# CHULLORA MATERIALS RECYCLING FACILITY

## Response to Submissions

10 JUNE 2021

Figure 1-2 MRF

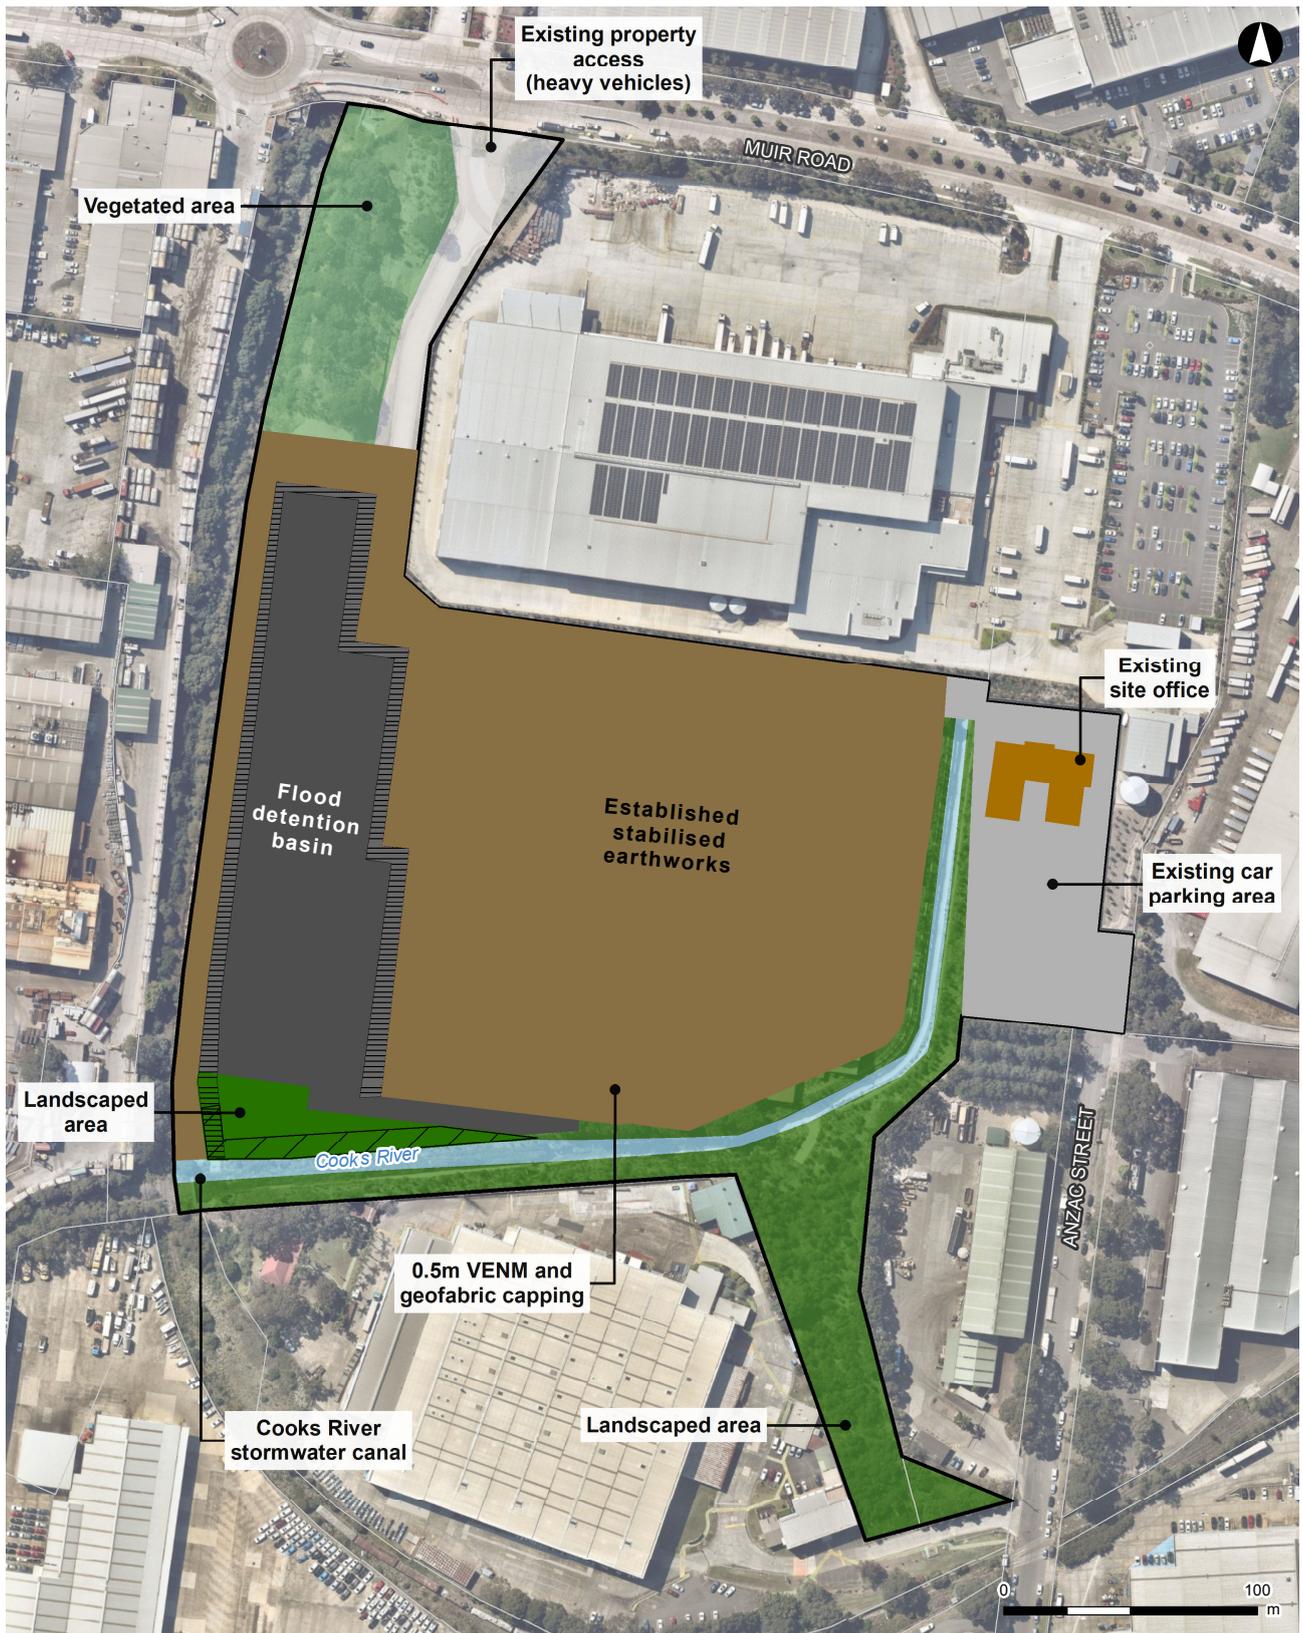
In order to improve efficiencies of internal processes of the MRF, further design development has identified the need for minor adjustments to the internal layout and external shutter door locations. These are identified on Figure 1-2. Adjustments to external door locations would result in the removal of one door on the eastern side of the MRF. The second door in this area would be retained but relocated slightly to the south (<10 metres).
